# PLANNING DIVISION STAFF REPORT

**Project Address:** 3901 Packers Avenue (District 18, Alder Myadze)  
**Application Type:** Planned Development District Alteration  
**Legistar File ID #:** [83737](#)  
**Prepared By:** Lisa McNabola, AICP, Planning Division  
Report Includes Comments from other City Agencies, as noted  
**Reviewed By:** Kevin Firchow, AICP, Principal Planner

**Requested Action:** Consideration of an alteration to an approved Planned Mobile Home Park (PMHP) District for 3901 Packers Avenue to amend the approved site plan.

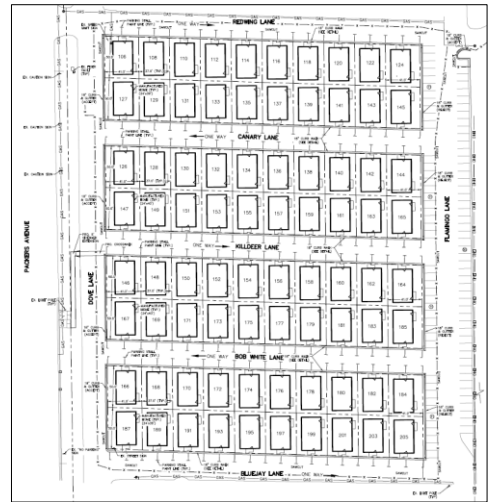
Staff note the site plan shows a stormwater management facility located partially outside of the property. The applicant will need to revise the site plan to locate the facility on their property, as noted in the recommended conditions of approval. The site plan may need to be further revised to address the recommended conditions of approval from the Fire Department. Some of the manufactured homes would be located more than 500 feet from the nearest hydrant, and the site does not provide adequate access for fire vehicles and hoses. In speaking with the applicant, they expect to revise the site plan to provide an additional fire access lane. They will continue to work with the Fire Department to ensure there is adequate fire hydrant access. The Planning Division recommends the following condition of approval to account for anticipated site plan changes, "The Planning Division Director, or their designee, may administratively approve site plan changes that address the recommended conditions of approval, which may include adding fire access lanes and removing manufactured home sites. If the Planning Division Director does not approve the changes the applicant may follow the alteration procedures per MGO Section 28.09(6)."
